Final Rule, Response to Petitions for Reconsideration, Technical Amendment, Docket No. 2008-0111, Anthropomorphic Test Devices; ES-2re Side Impact Crash Test Dummy 50th Percentile Adult Male.

First Technology Safety Systems (FTSS) has reviewed the February, 2008, ES-2re dummy drawing package (identified in the above mentioned technical amendment) and we have identified a number of drawing errors and a number of drawing issues. We seek to petition NHTSA to correct these drawings to ensure that the ES-2re dummy continues to meet the same dimensional and performance requirements established for the dummy when the dummy was proposed for inclusion into 49 CFR Part 572 Subpart U. FTSS makes the following comments and recommendations with respect to the drawing package. A marked up drawing for each of these recommended changes are attached to the end of this letter.

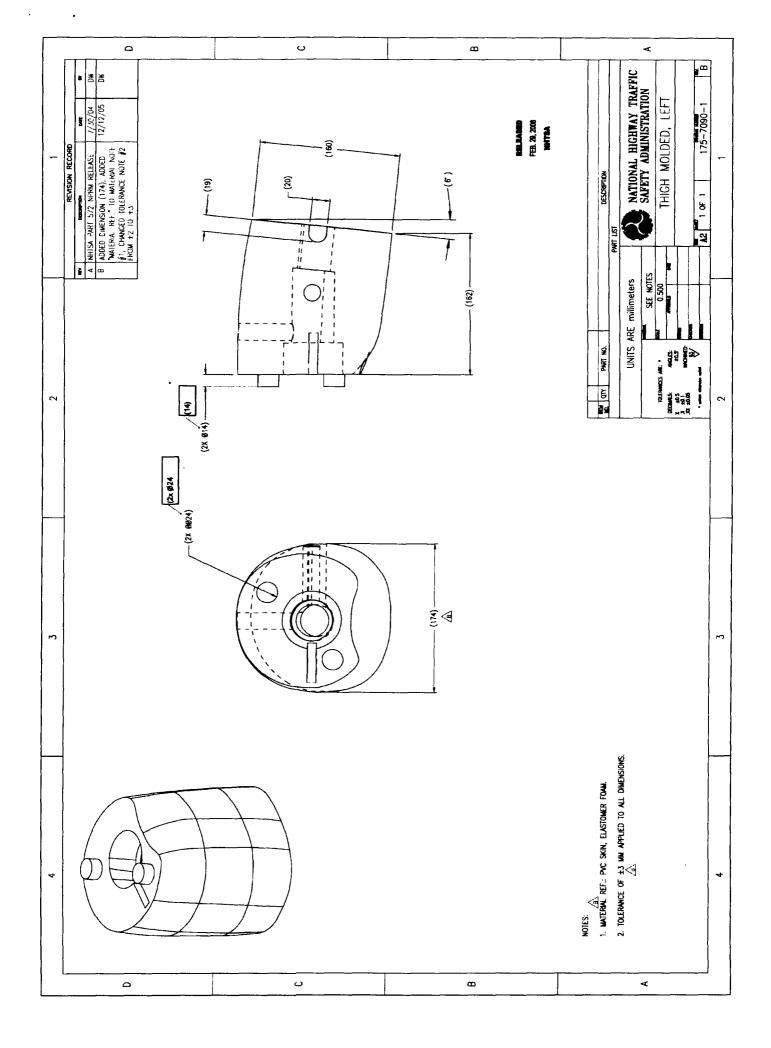
- 14) Drawing 175-7090-1, Thigh Molded, Left. Fix typographical errors for drawing dimensions "(2x ØØ24)" and "(2x Ø14)". These dimensions should be listed as "(2x Ø24)" and "(2x14)". Removal of extra or redundant Ø symbol is required. This would also make this part consistent with the Thigh Molded, Right drawing (NHTSA Drawing 175-7090-2).

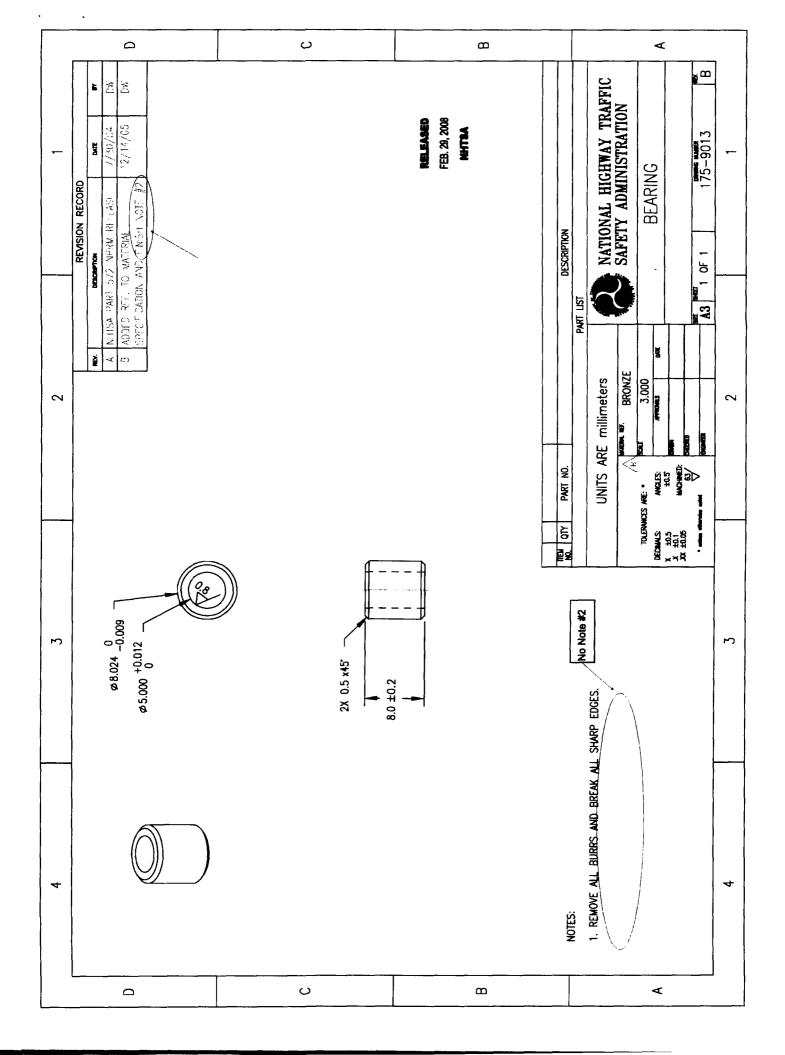
- 15) Drawing 175-9013, Bearing. The drawing has a reference to Note#2 in the revision record (REV B), but the note is missing from the "NOTES" field. FTSS recommends that the note be added to the note field, or the note reference be eliminated from the revision record.

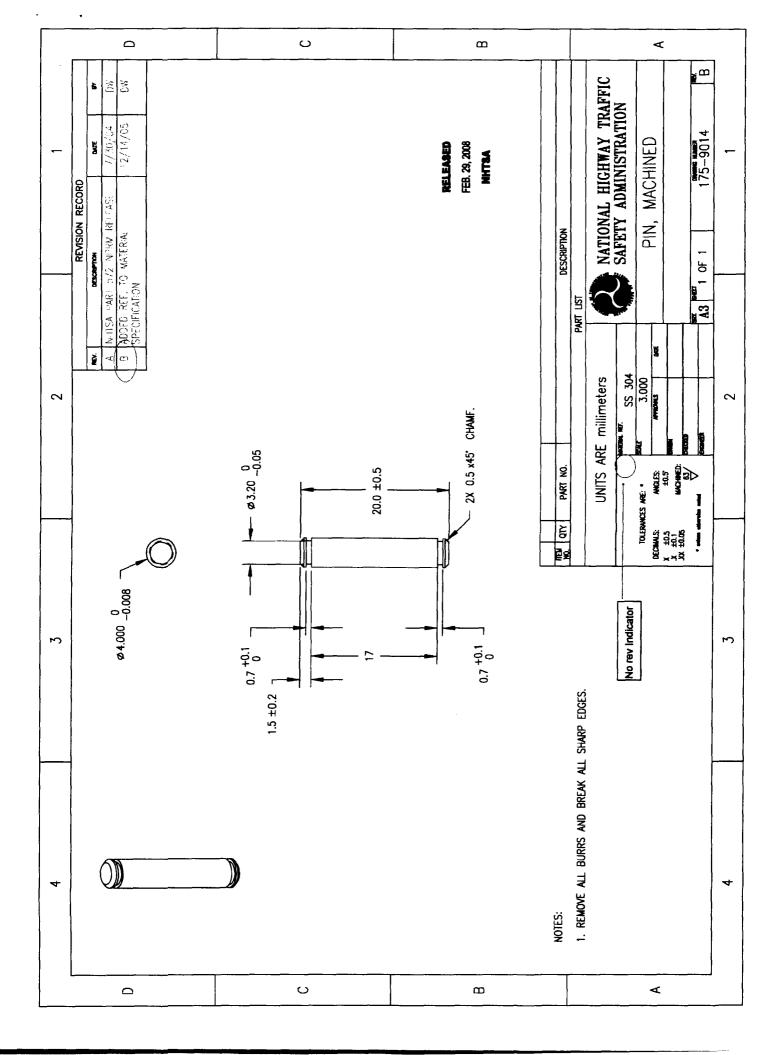
- 16) Drawing 175-9014, Pin Machined. Correct typographical error for missing revision indicator for REV B on the Material Reference. The revision record states "ADDED REF. TO MATERIAL SPECIFICATION"; however no revision reference bubble was added.

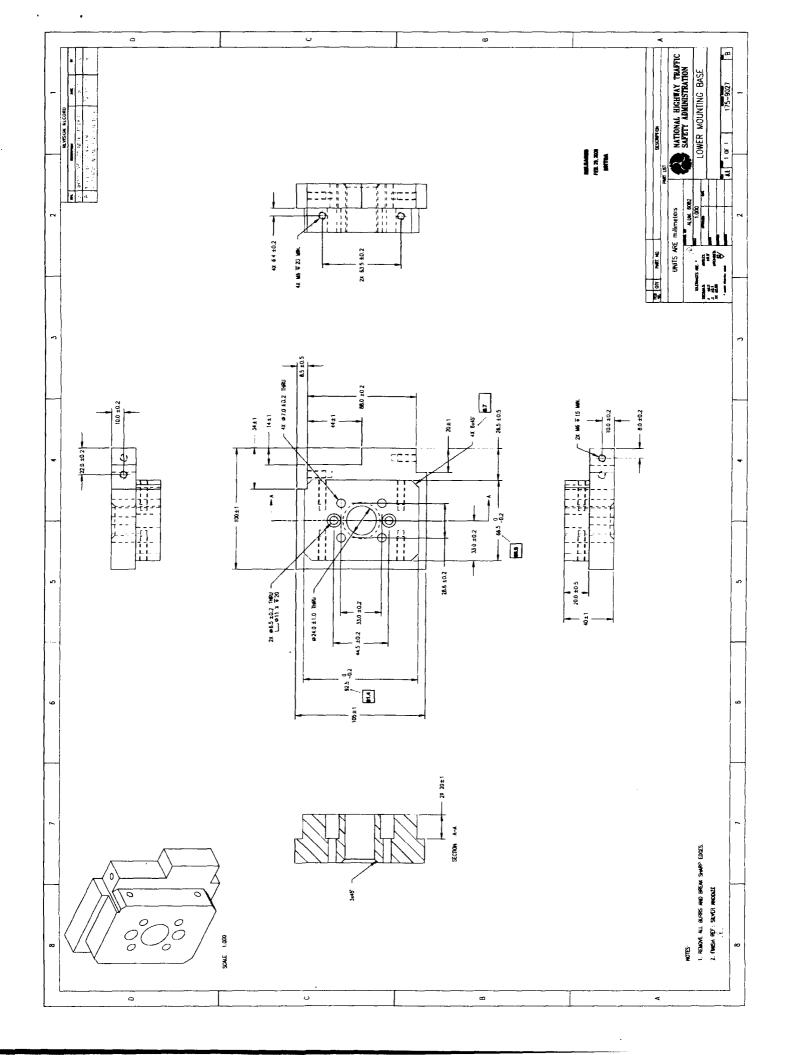
- 17) Drawing 175-9027, Lower Mounting Base. FTSS recommends that the following NHTSA dimensions "92.5 +0 / 0.2", "66.5 +0 / -0.2", and "4 x 6 x 45°" be replaced with "91.4 +0 / -0.2", "66.0 +0 / -0.2", and "4 x 9.7 x 45°" respectively. We recommend these changes due to the wider tolerances associated with typical product dimensions specified for the 3" x 4" tubular steel beam that the Lower Mounting Base fits into. These tolerances are typically ± 0.030 for the tubular beam so our recommended dimensional changes for the Lower Mounting Base is necessary to guarantee that the Lower Mounting Base will fit into the wide variety of pendulums beams in the marketplace.

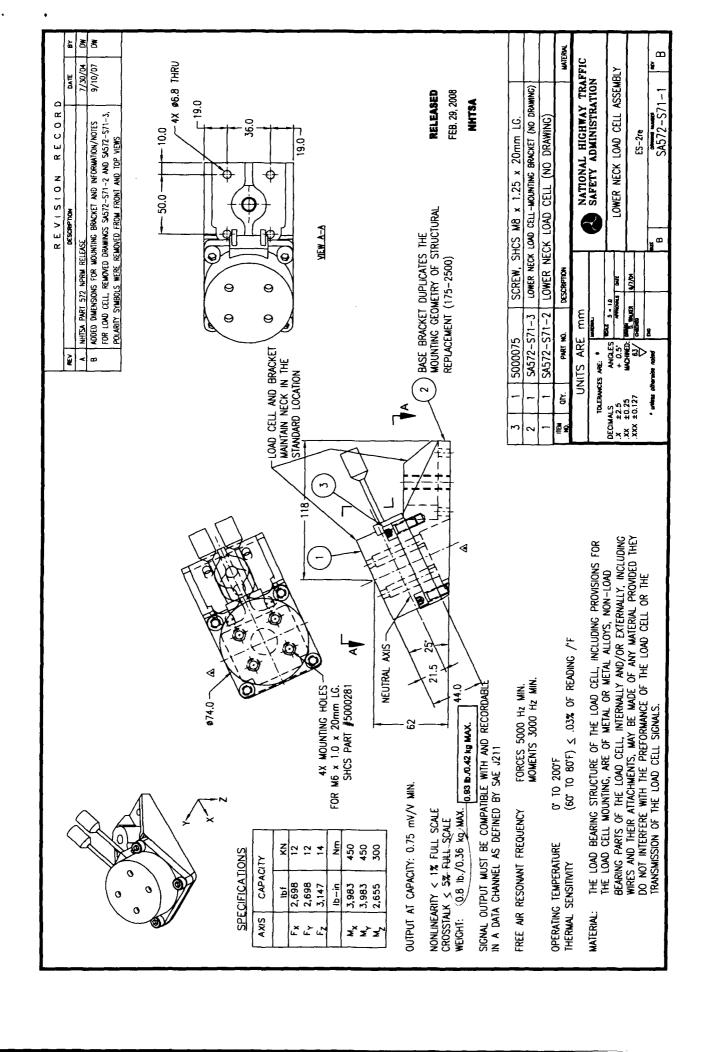
- 18) Drawing SA572-S71-1, Lower Neck Load Cell Assembly. FTSS recommends that specification of the part weight be correct to include the weight of the two connector/cable assemblies. The weight currently specified for this part in the NHTSA drawing is "0.8 lb. / 0.36 kg MAX." However, this weight does not include the weight of the electrical connector/cable assemblies. Since the cables are hard wired to the load cell, they need to be included in the total weight. Therefore, we request that the assembly weight be listed as "0.93 lb. / 0.42 kg MAX" to include the two cable assemblies.
